UNIVERSITY OF WISCONSIN
NUCLEAR REACTOR
LICENSE NO. R-74
DOCKET NO. 50-156

LICENSE RENEWAL APPLICATION
SAFETY ANALYSIS REPORT,
AND
TECHNICAL SPECIFICATIONS
REVISION 2

Subject: License Renewal of the University of Wisconsin Nuclear
Reactor; License R-74, Docket 50-156

The changes described in the attachment are indicated by a vertical line in the margin of the enclosed revision 2 to the Safety Analysis Report for Renewal of License R-74 for the University of Wisconsin Nuclear Reactor, dated September 2008.

Figure 5-2 Pool Water Systems

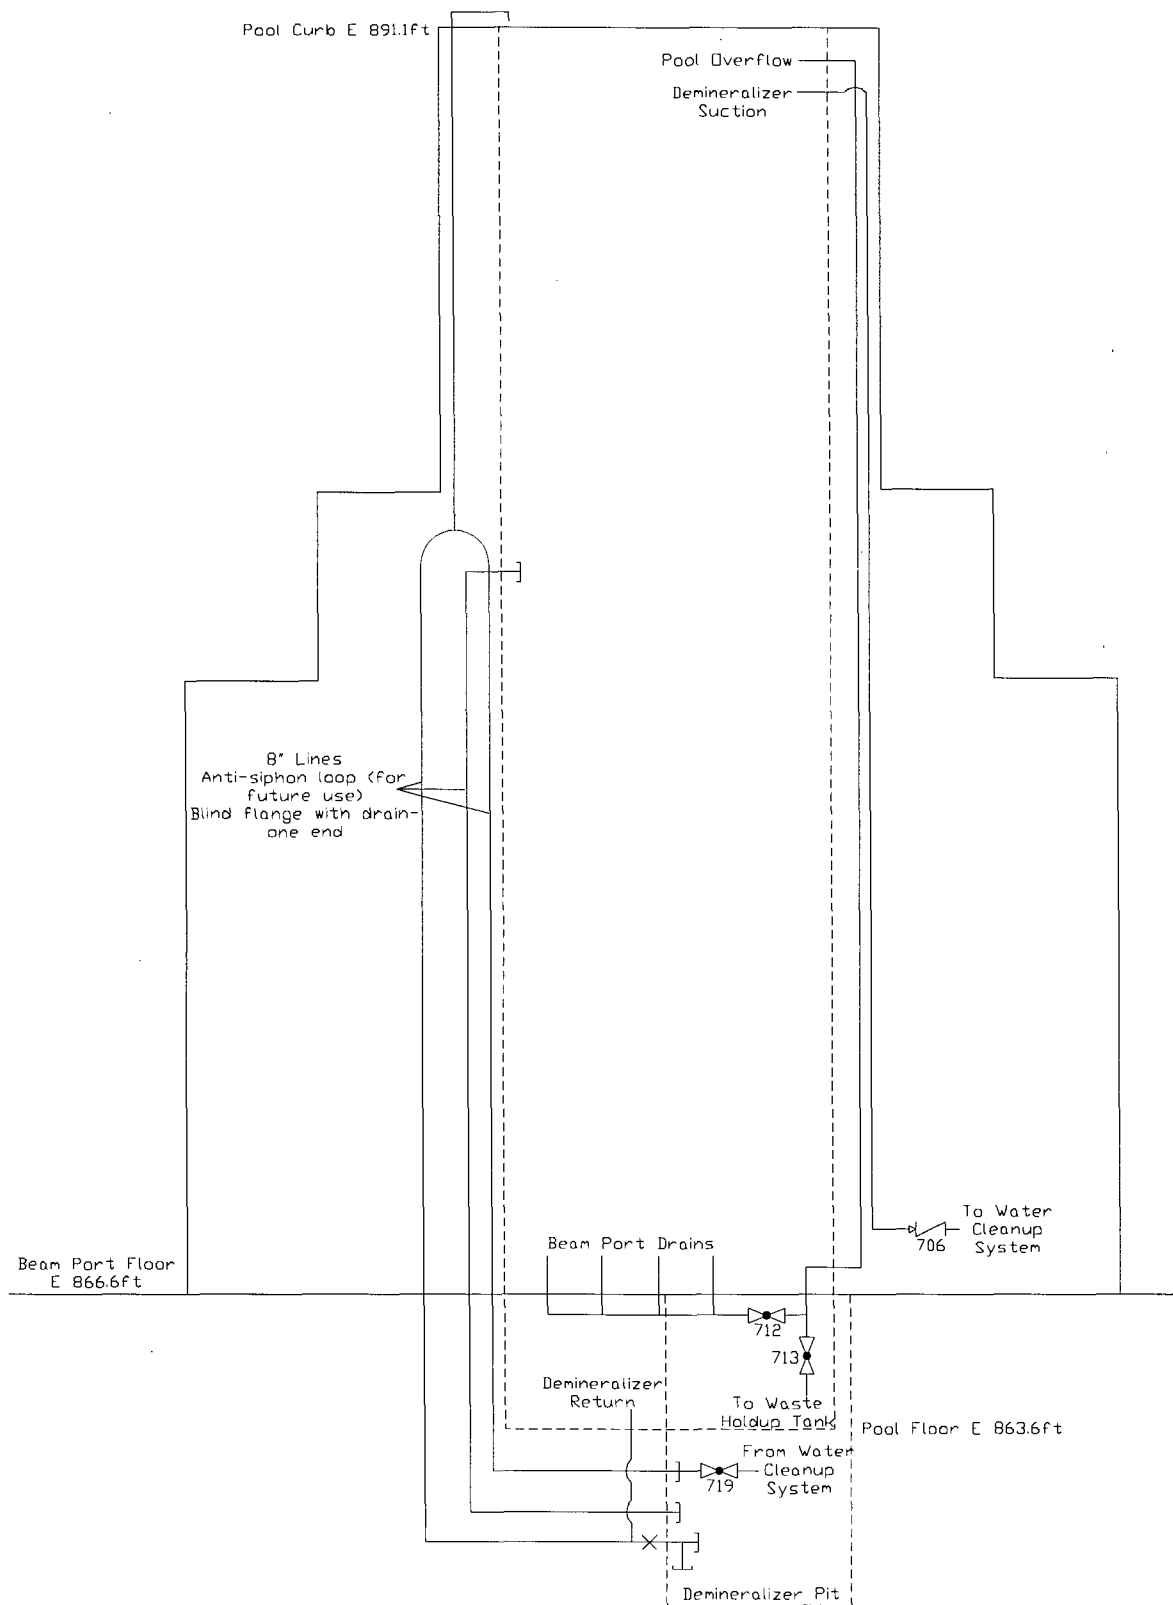
Section	Rev2 Page	Change	Reference
Chapter 5			
5.5	5-3,4	Split sections 5.5 and 5.6 (water cleanup and makeup sections) for clarity. Also added description of waste system to section 5.5. Previous Figure 5-2 has also been updated and split into Figures 5-2, 5-3, 5-4, and 5-5 to separate pool, cleanup, makeup, and waste systems.

5.5	5-3,4	Updated flow rate and valve numbers for new demineralizer (18 gpm, valve 10102 service out, valve 22).	
Figure 5-2	5-5	Added new pool water systems schematic.	
Figure 5-3	5-6	Added new water cleanup system schematic.	
Figure 5-4	5-7	Added new water waste system schematic.	
Figure 5-5	5-8	Added new water makeup system schematic.	
Chapter 6

Figure 7-3 Magnet Power Supply

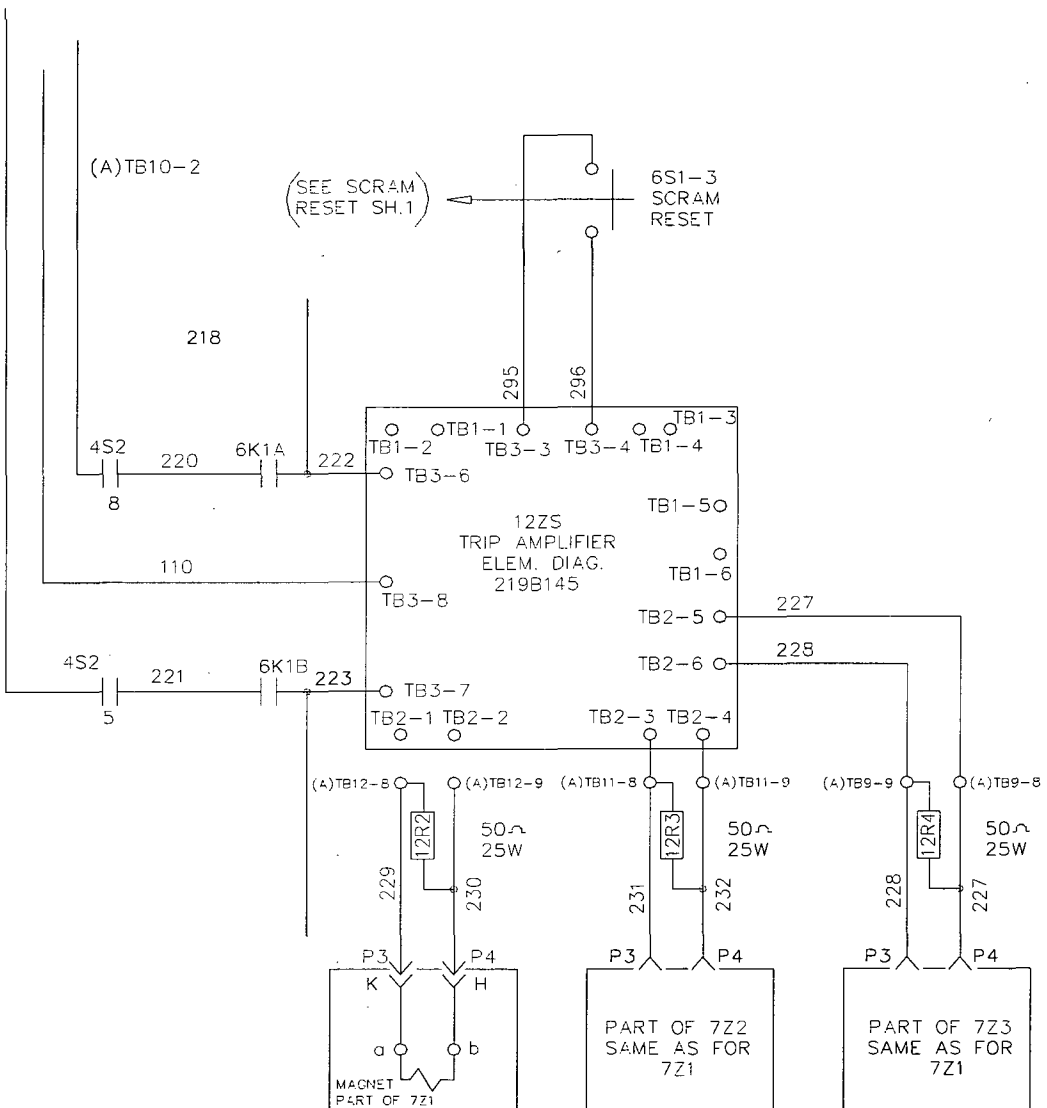
7.4	7-10	Removed reference to LogN not in operate scram which was removed.	RSC 887 ⁽⁴⁾
7.4	7-10	Clarified that pool level alarm is on high or low.	
Figure 7-2	7-11	Updated per console upgrade.	RSC 887 ⁽⁴⁾
Figure 7-3	7-12	Updated per console upgrade.	RSC 887 ⁽⁴⁾

Figure 9-1 Ventilation System Schematic

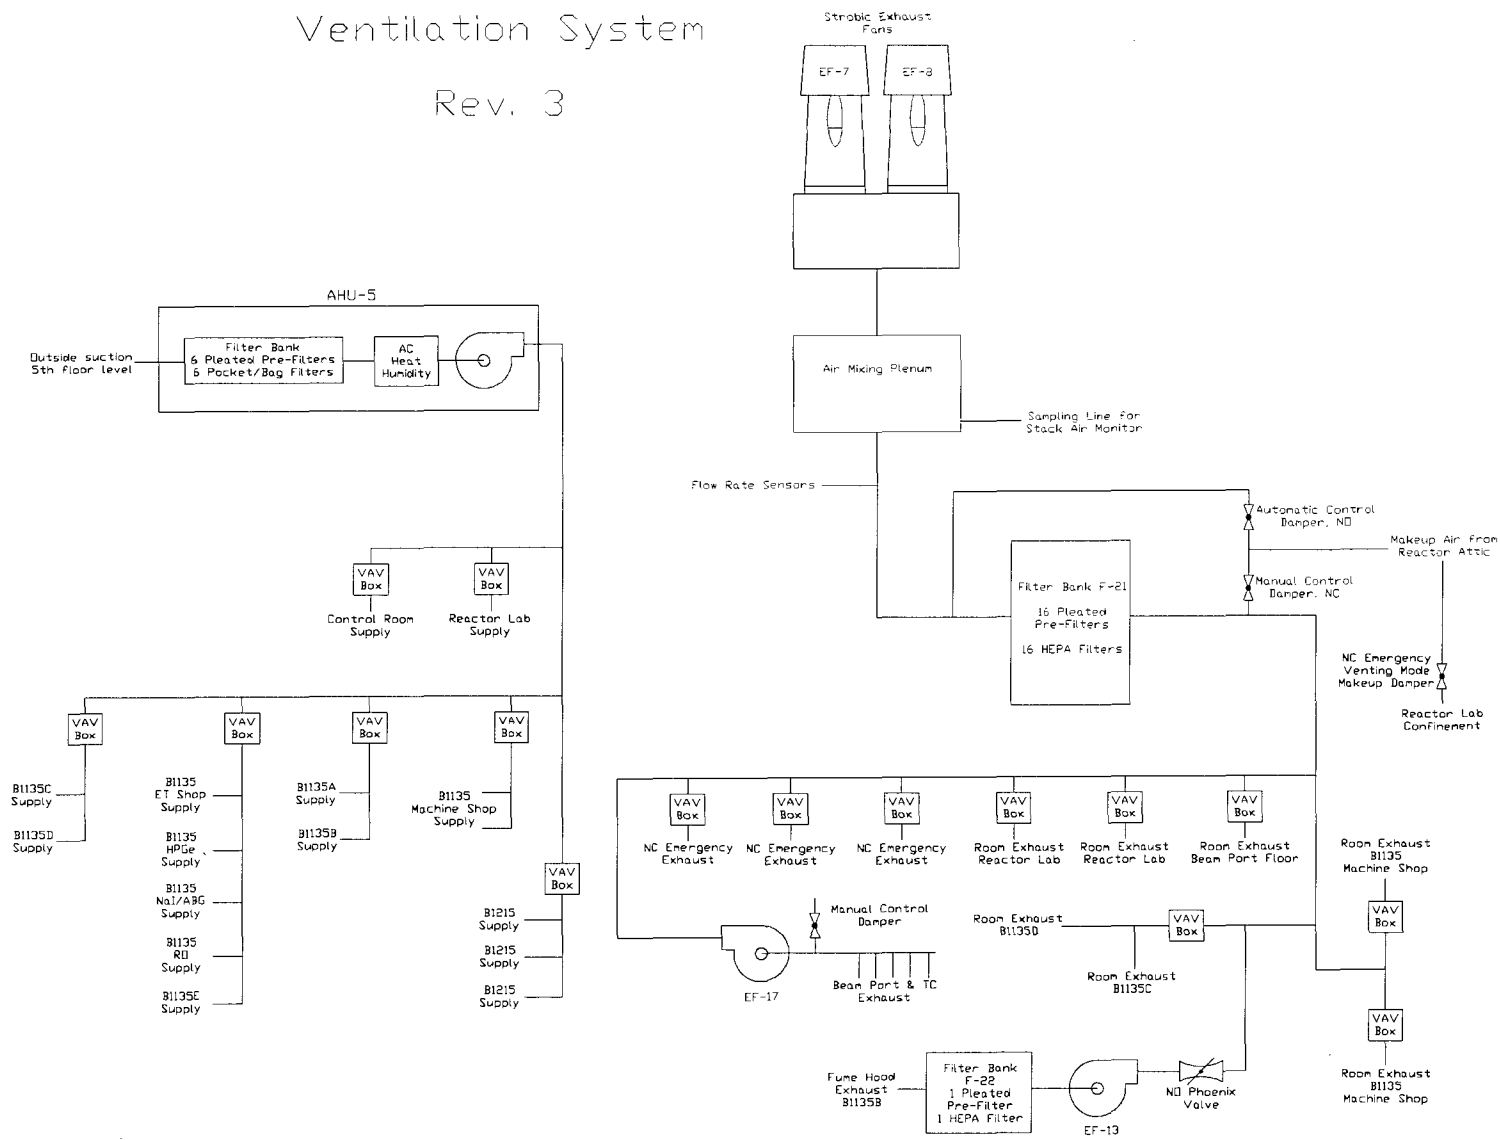
9.1	9-1,2,3,4	Rewrote ventilation system description. This is a complete rewrite which is based on the RSC description.	RSC 879 ⁽⁹⁾
9.1.#	9-1,2,3,4	Added outline numbering.	
Figure 9-1	9-5	Updated for new vent system.	RSC 879 ⁽⁹⁾
Figure 9-2	9-6	Added new figure 9-2 for cross-section ventilation layout.	
Figure 9-3	9-7	Added new figure 9-3 for cross-section ventilation layout.	
Figure 9-4	9-8	Revised fuel rack diagram to reflect actual locations, and added North legend.

Figure 14-1 Organization Chart

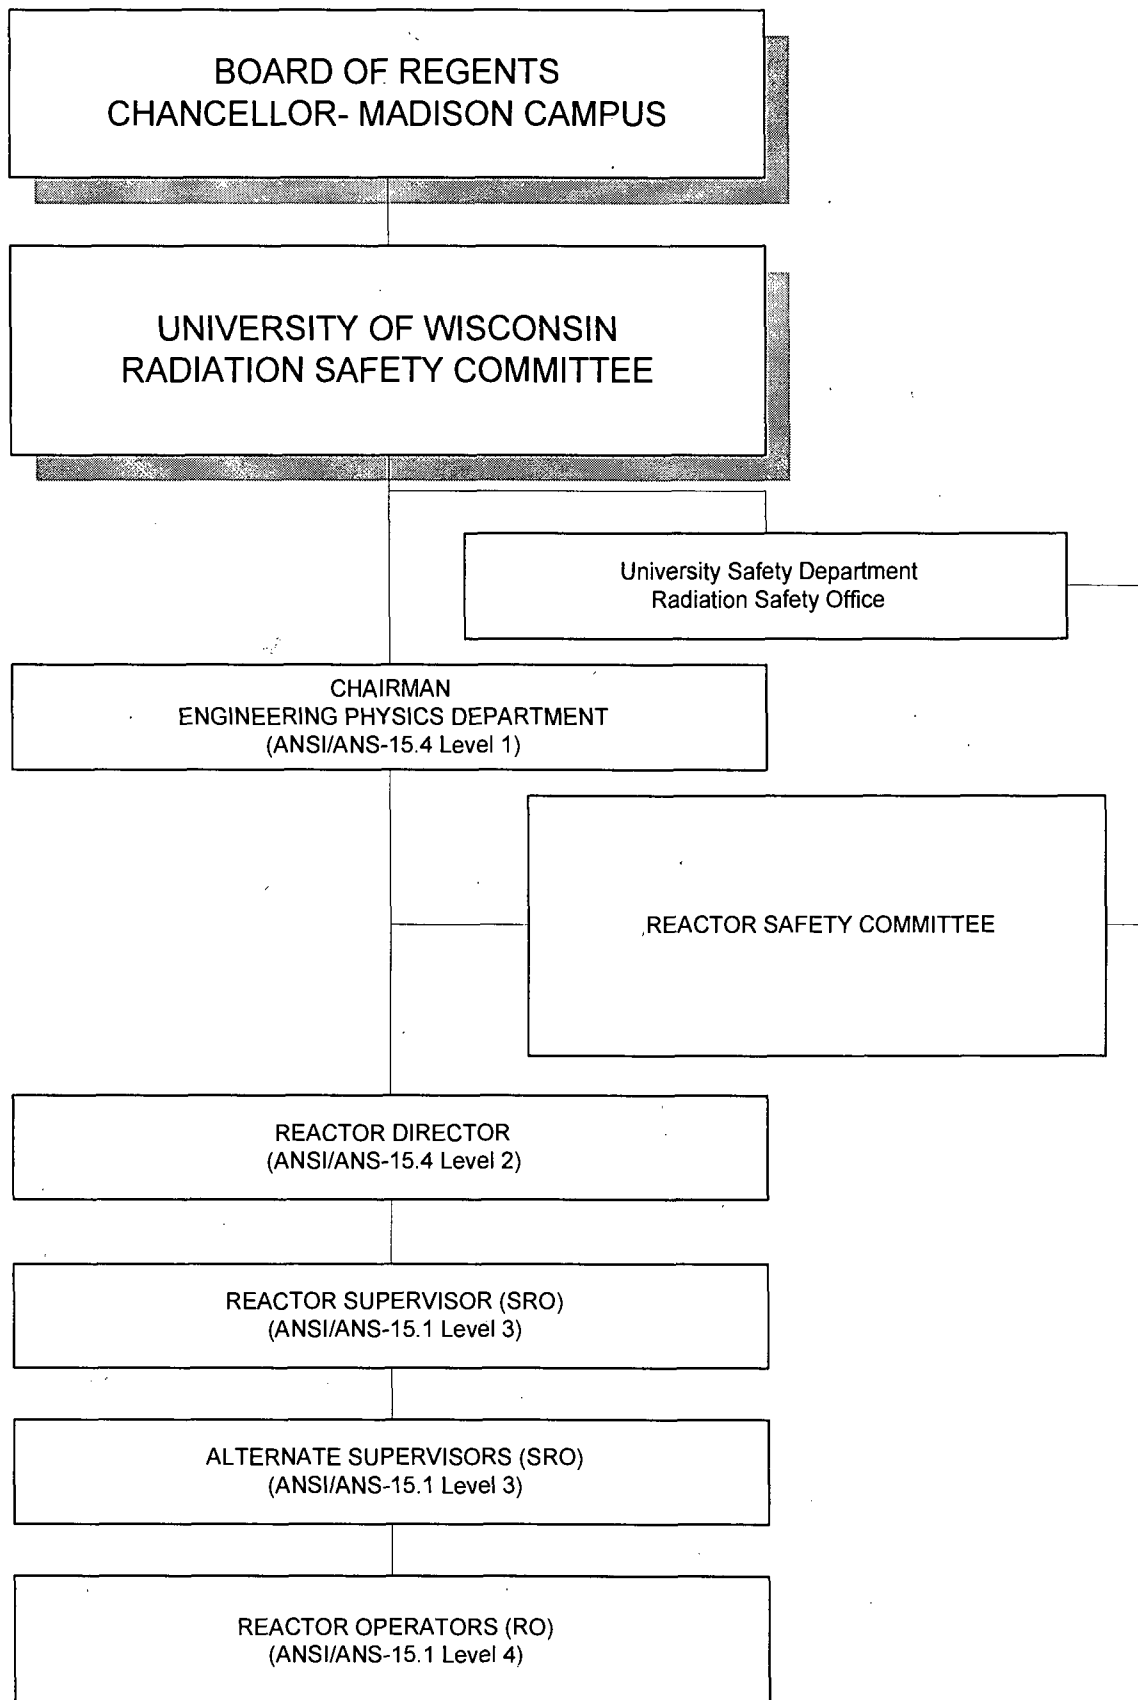
5.3	14-42	Revised outline numbering for consistency.	
6.1.1	14-45	Added reference to new Figure 14-1 (just copy of Figure 12-1).	
6.1.2	14-45	Fixed gender language.	
Figure 14-1	14-46	Added new figure for clarification (copy of Figure 12-1).
